PROJECT: William K. Moore E.S. CCSD #0695

TELEPHONE RECORD

SUBJECT: Off site improvements

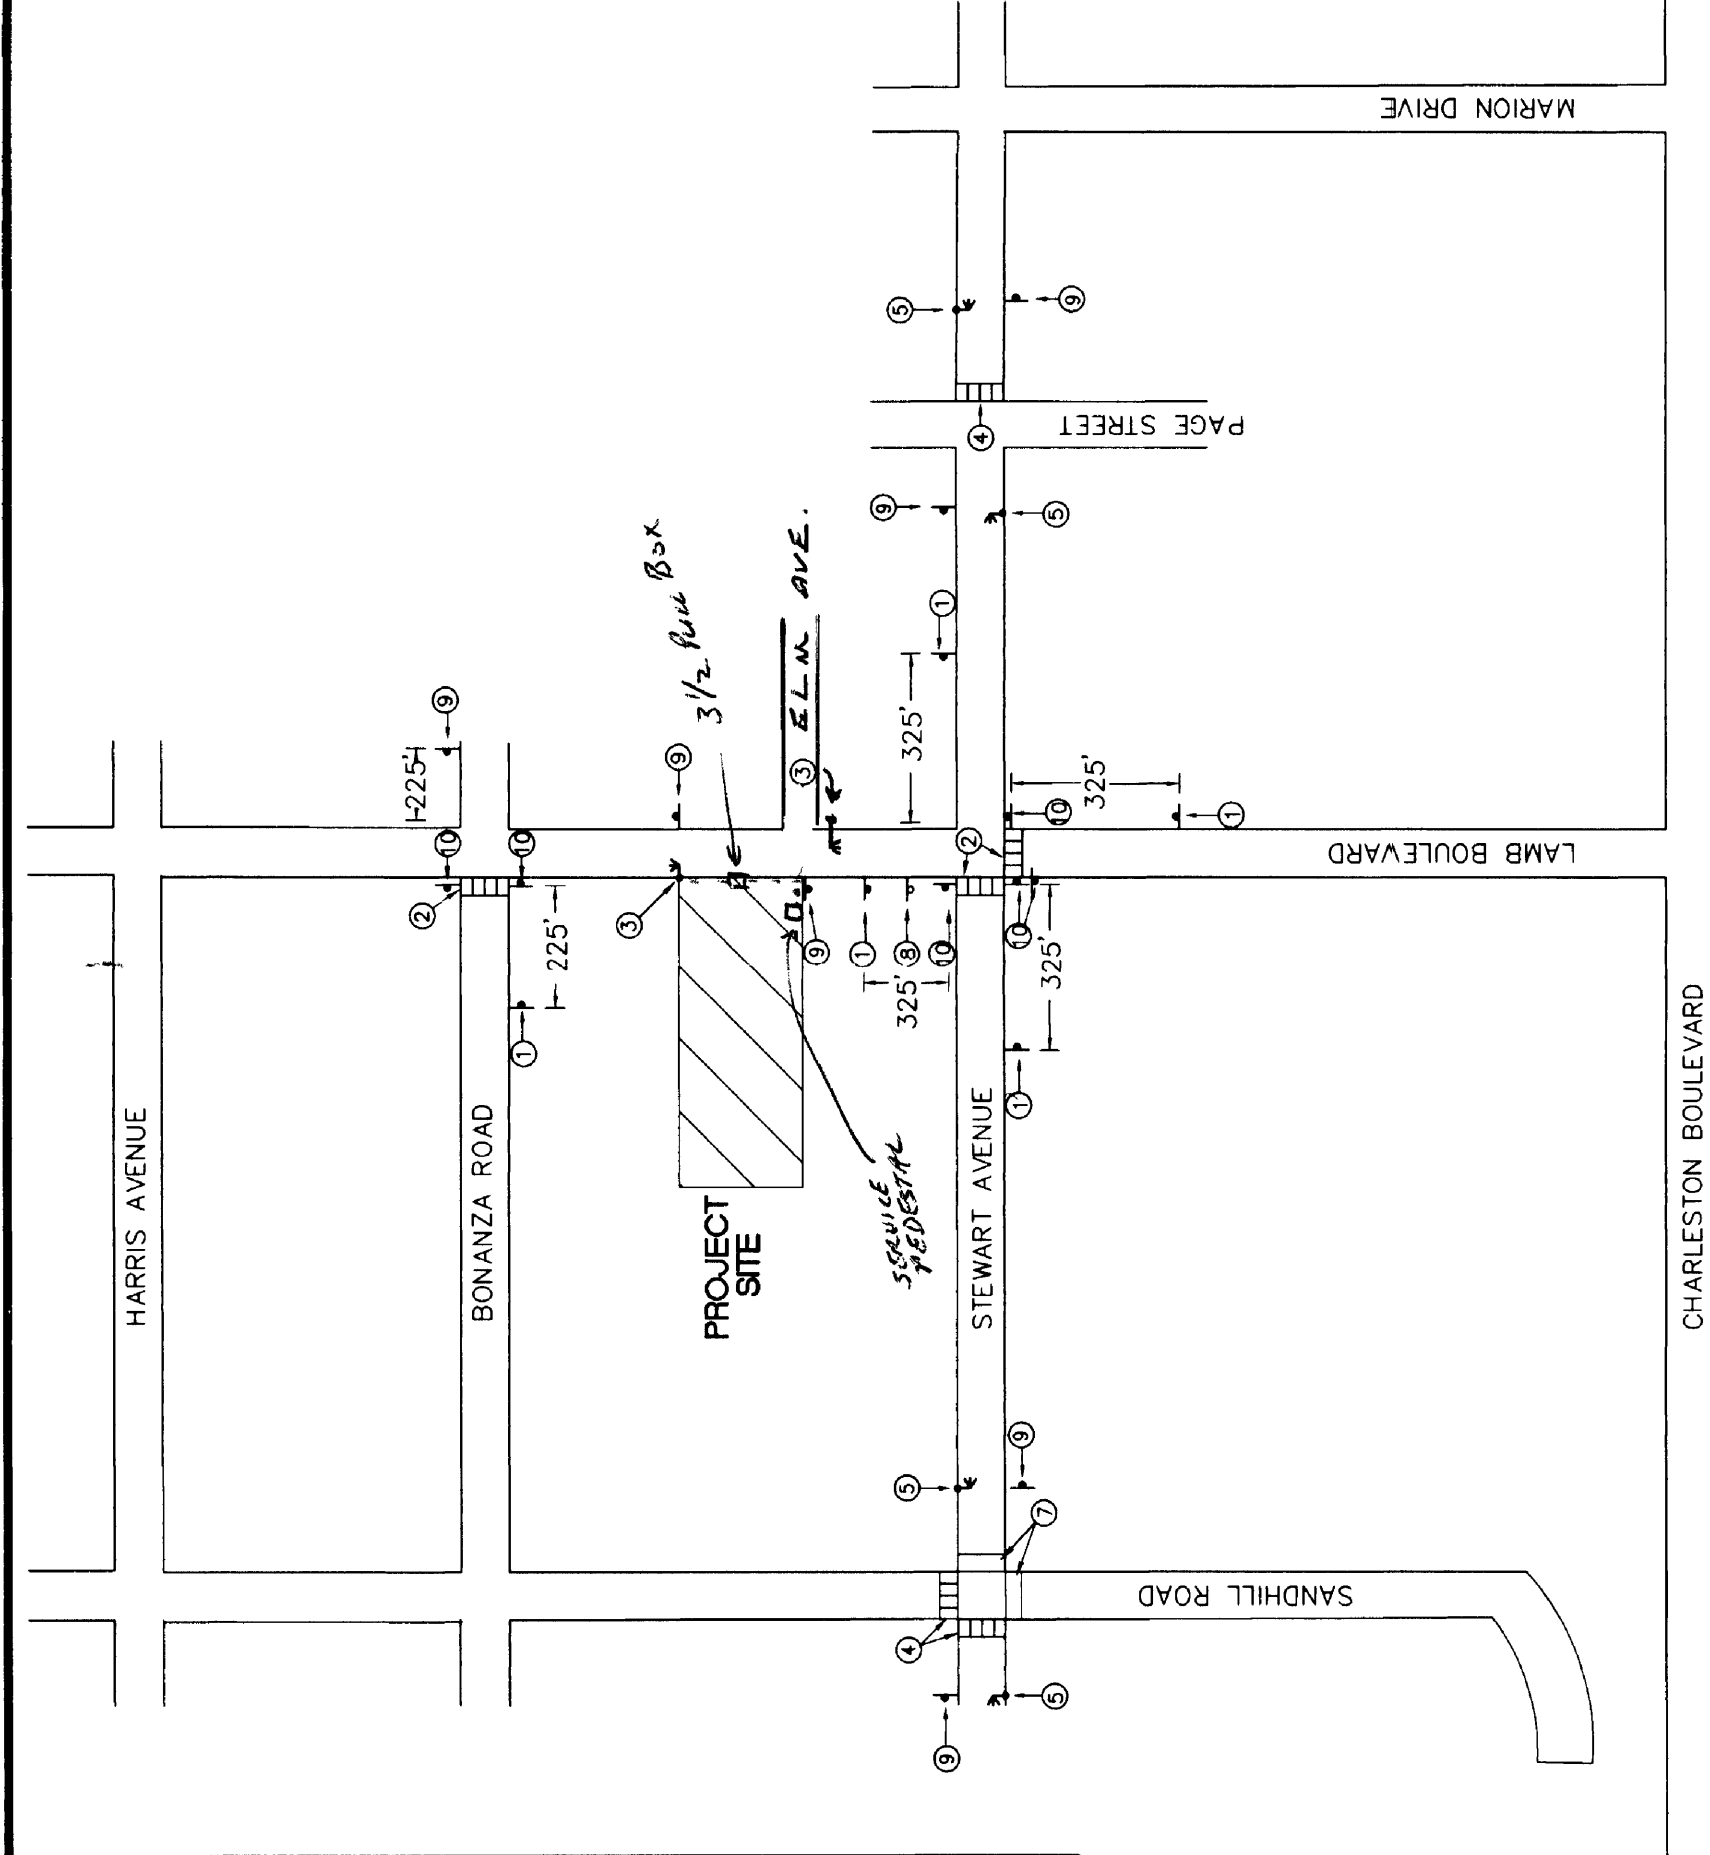
Mr. Snyder was asked if the Roche Construction had completed their responsibility as far as the flashing beacons are concerned. Mr. Snyder indicated the following were still incomplete:

1. Crash caps have not been installed at the flasher pole bases.
2. There is a section of sidewalk on the east side of Lamb Boulevard that has not been replaced where underground conduit has been installed.

3. The power service pedestal for the flashers has not been energized. It is required that NPCo receive a request from the CLV to energize the pedestal. The CLV must receive a request for inspection from Roche prior to requesting service from NPCo. Mr. Snyder also noted the wire from the transformer to the service pedestal must be installed by Roche (Vita). Roche should contact Manny Windhorst (375-6197) to schedule inspection.
